UNITED STATES OF AMERICA
NUCLEAR REGULATORY COMMISSION

(Diablo Canyon Nuclear Power)
Plant, Units 1 and 2))

HISTORY OF ONSITE ENGINEERING
SMALL BORE PIPING PROGRAM DESCRIPTION

AFFIDAVIT OF M. TRESLER, R. OMAN, AND M. LEPPKE

1) FLARE BEVEL AND FLARE - V GROOVE WELDS

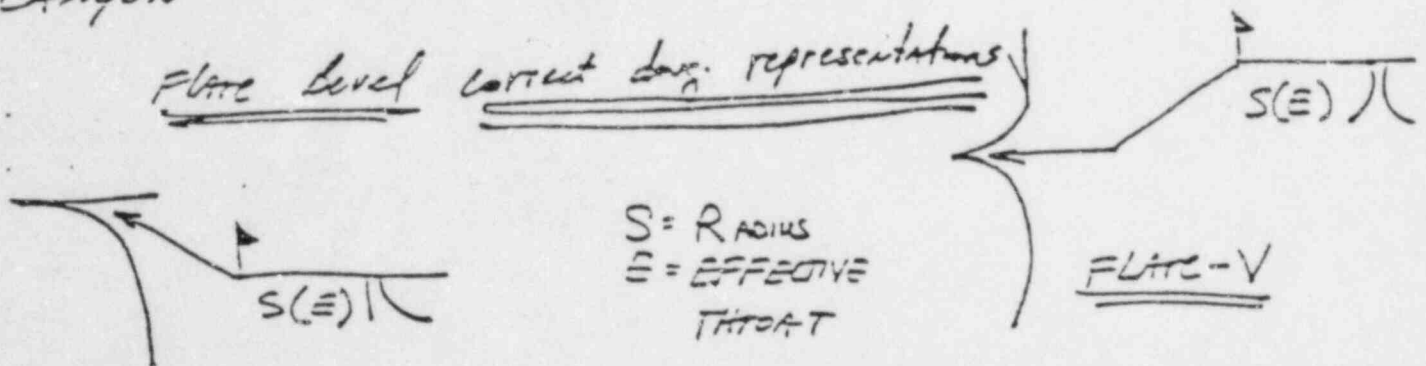
Drawing Representation BECHTEL SAN. FRAN. ...
No Partial welds are shown since S (E) ...
Have been omitted. AWS. 2.13. & 2.10.3.1 +
2.10.3 state that (S) groove depth & (E) ...
... shall be specified on ...
DWS. THE HANGER DWS. SENT TO THE FIELD ARE
BOTH SHOP & WORKING DWS. ALSO M-9 STATES THAT
ONLY PRE-QUALIFIED JOINTS SHOULD BE USED ON DIABLO
CANYON

BECHTEL SITE ONE GROUP HAS COMPLIED WITH
CALLOUTS ABOVE. HOWEVER, PULLMAN QC PER ESD 223
HAVE RECD THE REMOVAL OF S(E) FROM ALL FIELD
THEY ... BEEN SUGGESTED ...
FLARE BEVEL & FLARE-V SYMBOLS LEFT; INDICATE FULL
PENETRATION WELDS EVEN THOUGH, Q.C. STATES THIS IS NOT
THE CASE.

3. SKewed JOINT FILLET WELDS

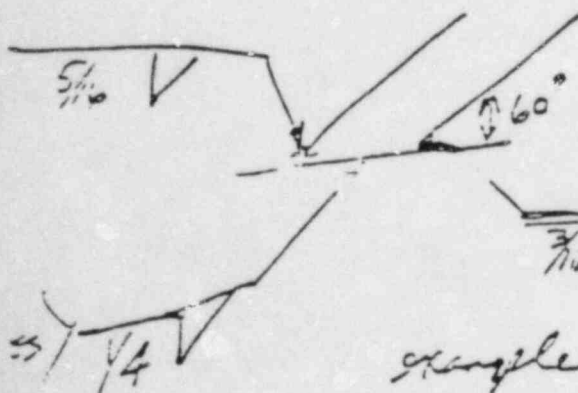
Drawing representation Bechtel San Fran.
 Per Dwg. are shown as later allowance for all
 angles. I'm sure no reduction was made for effective
 throat according to dihedral angle correction in calculation.
 I'm sure that calc. were made without consideration of
 dihedral angle

Bechtel site one group has considered dihedral
 angle. To facilitate design, joint was sized assuming
 90° fillet or a constant effective throat size. After
 sizing either 90 fillet legs or obtaining effective
 throat requirements for 90° joint then using dihedral
 angle the 2 non-90° sides were adjusted so that
 installed effective throat would be equivalent in size
 hereby ~~facilitating~~ calculation.

- (1) Assume 90° obtain effective throat
- (2) adjust exterior and interior leg
 calculated considering dihedral angle
 adjustment.

3. SKEWED JOINT FILLET WELDS DESIGN

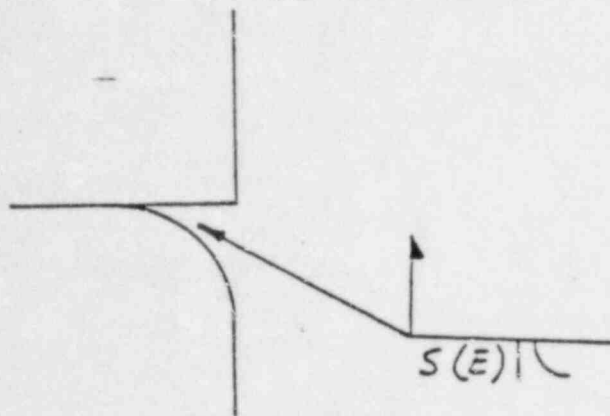
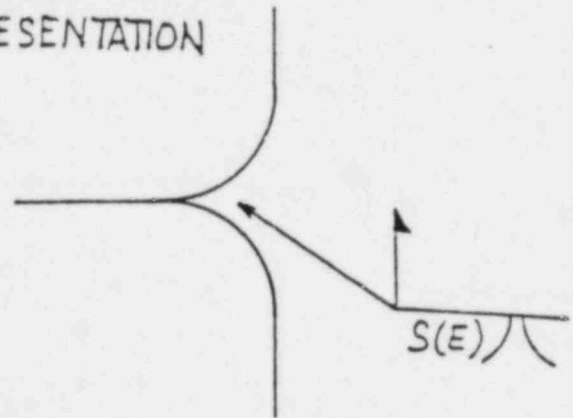
Bechtel San Francisco-Per drawings supplied to field and continued use of fillet all around call out instead of a specific call out adjusting the leg size for the dihedral angle adjustment. It's obvious that the dihedral angle has not been considered in the joint design or if it was, it was done incorrectly.

Bechtel Site-One group has tried to be consistent in adjusting the inner and outer fillet leg size based on dihedral angle so that the effective throat on all sides is the same. This allows the joint to be analyzed as though it is an equal leg fillet all around with only a leg adjustment to obtain this when welded. This is shown on drawing, so construction only has to make what is shown and not interpret what is shown using a table which is not usually at hand.
